Re: S/D 93-29 BRITTAIN INDUSTRIAL PARK ADDITION - (Revised Final Plat)

**STAFF REPORT
(Revised Final Plat)
(Final Plat Approved 10/14/93, Preliminary Plat Approve 5/27/93)**

CASE NUMBER: S/D 93-29 - BRITTAIN INDUSTRIAL PARK ADDITION

BRITTAIN INDUSTRIAL PARK

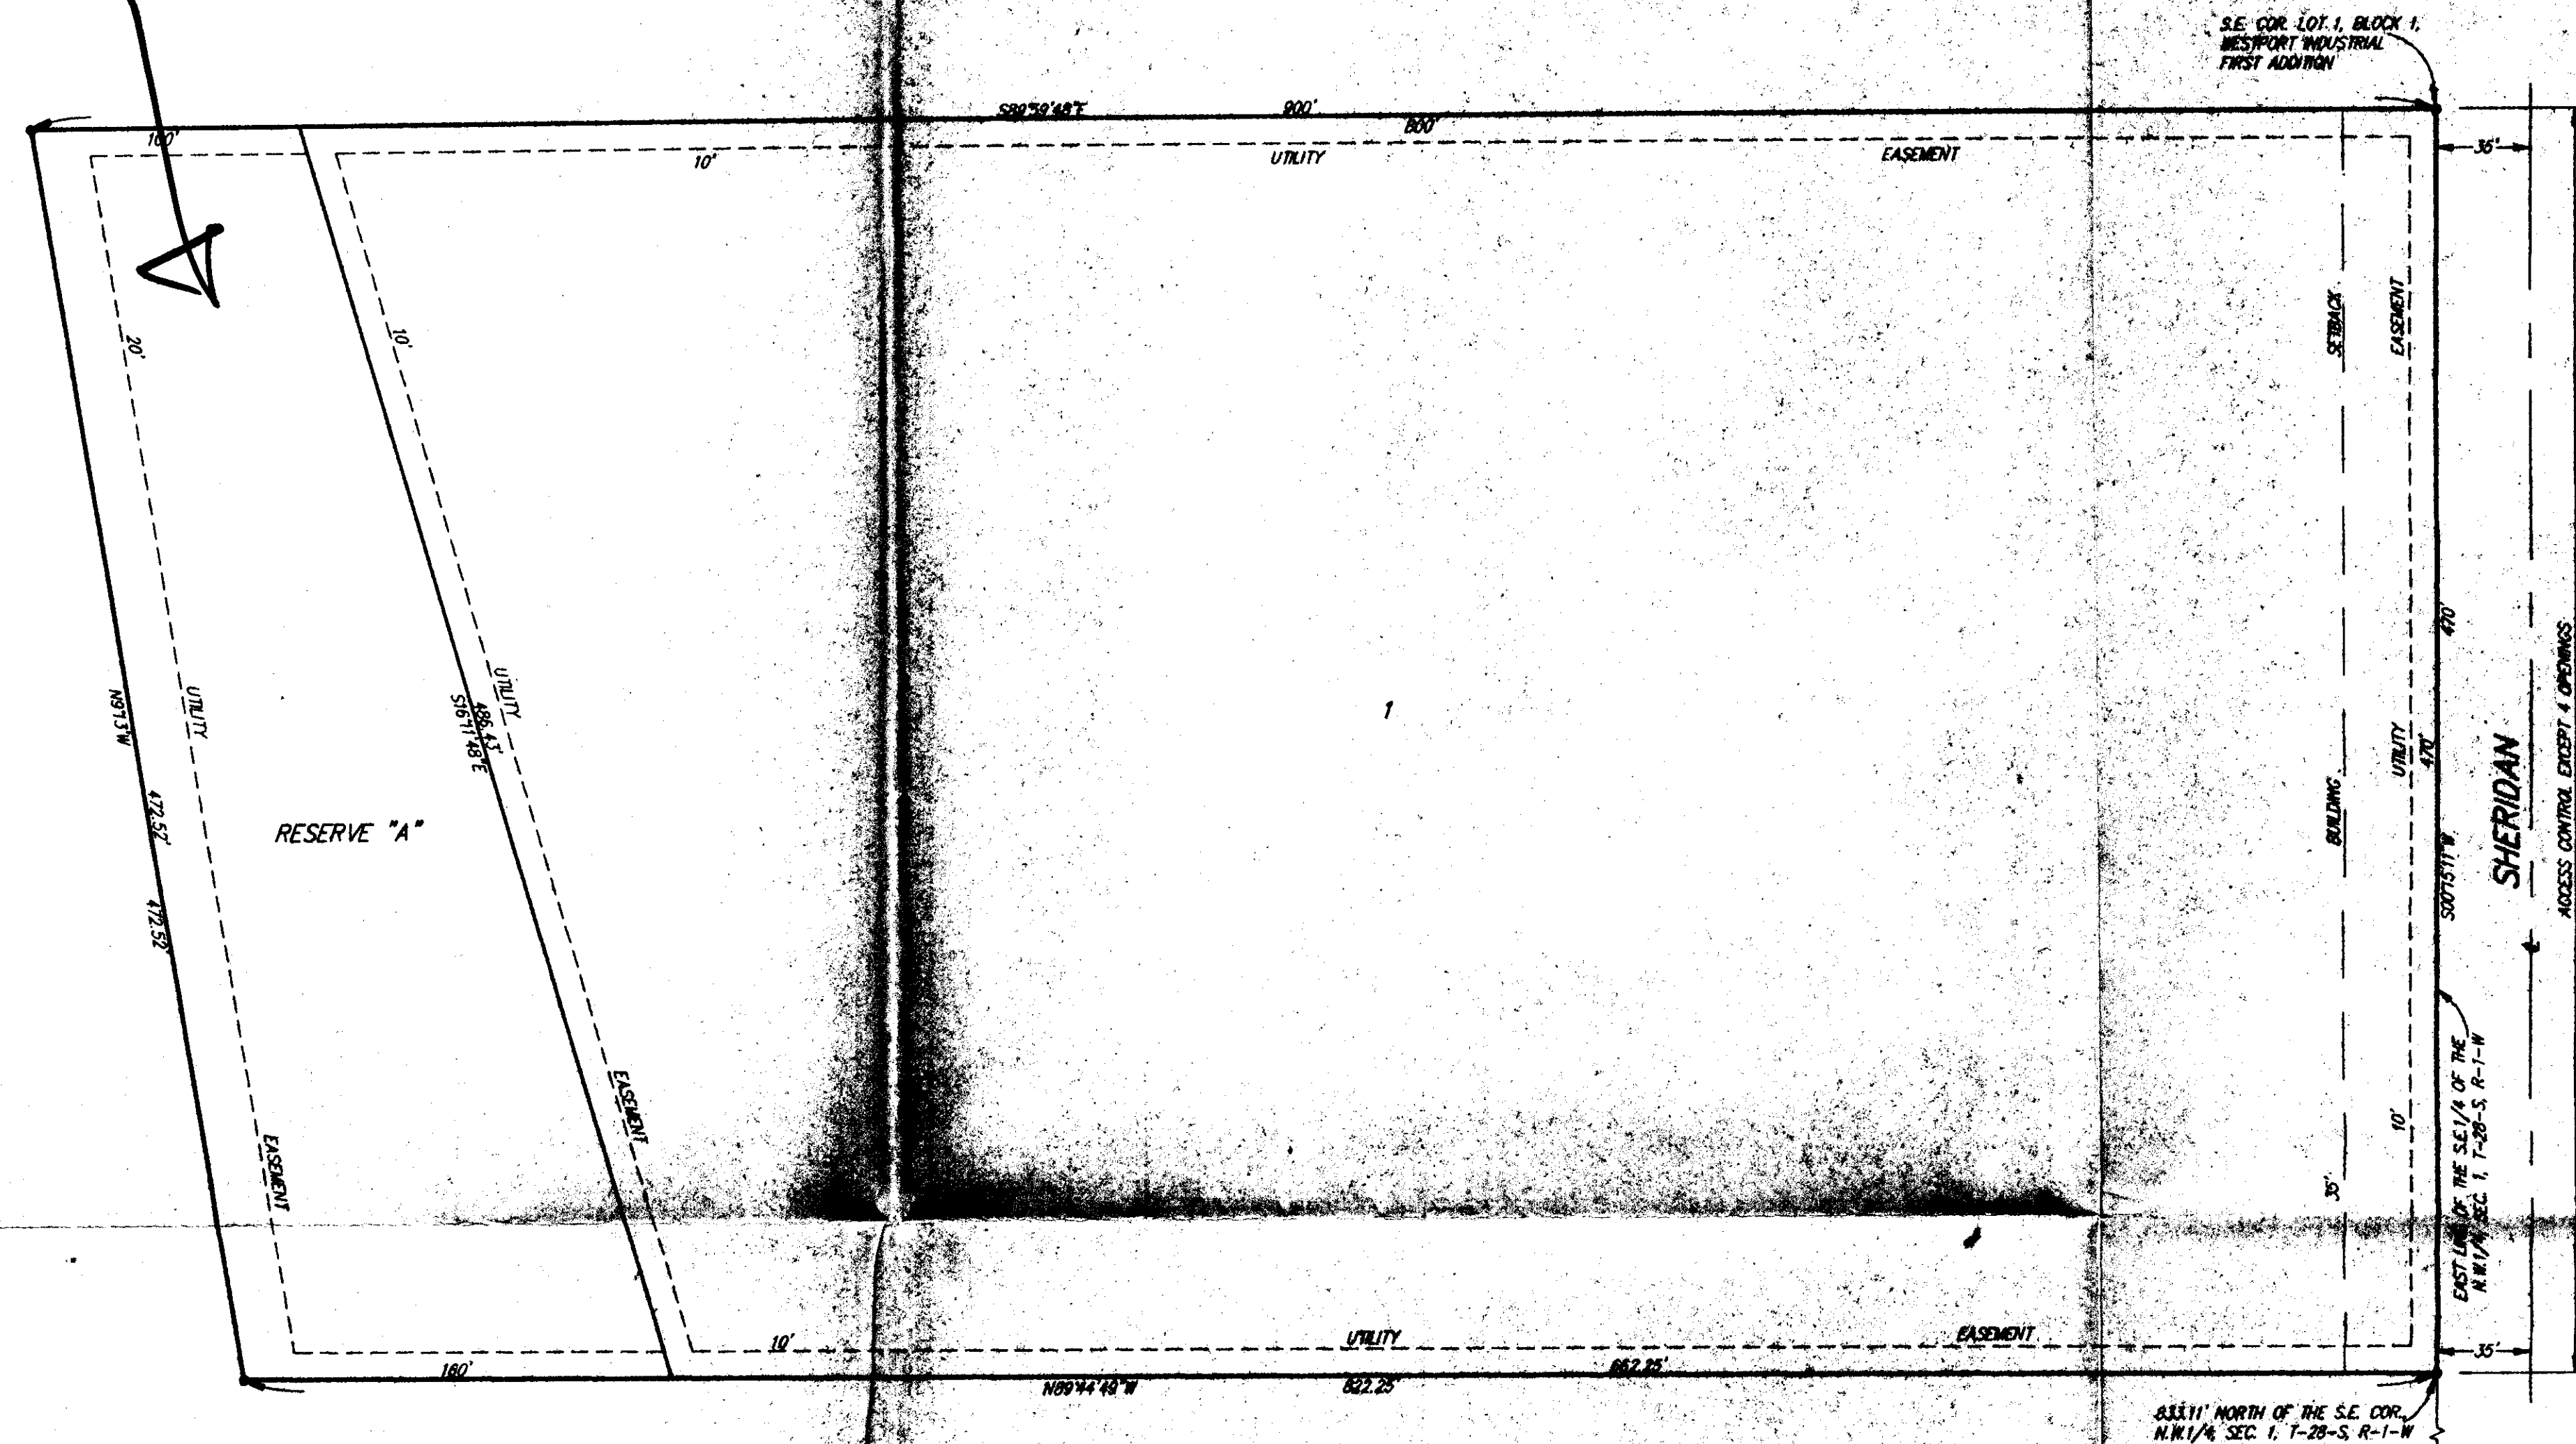
NOTE: This final plat has been revised by eliminating an area originally platted as a Reserve needed for drainage. City Engineering has confirmed that the Reserve is not necessary and may be eliminated.

- A. Since Sheridan is not an arterial and the zoning either side of this street is light industrial, no access controls need to be dedicated. The final plat tracing shall, therefore, eliminate the references to access controls shown on the face of the plat and within the plat's text.

- C. The applicant's engineer is advised that the Register of Deeds is requiring the name(s) of the notary public, who acknowledges the signatures on this plat, to be printed beneath the notary's signature.

- E. As indicated by the Sedgwick County Soil Conservation District, a portion of this site involves hydric (wetland) type soils and development may require approval in such areas by certain Federal Agencies (Army Corps Engineers).

- F. Perimeter closure computations shall be submitted with the final plat tracing. Section 5-101(C).
- G. Recording of the plat within 30 days after approval by the City Council.
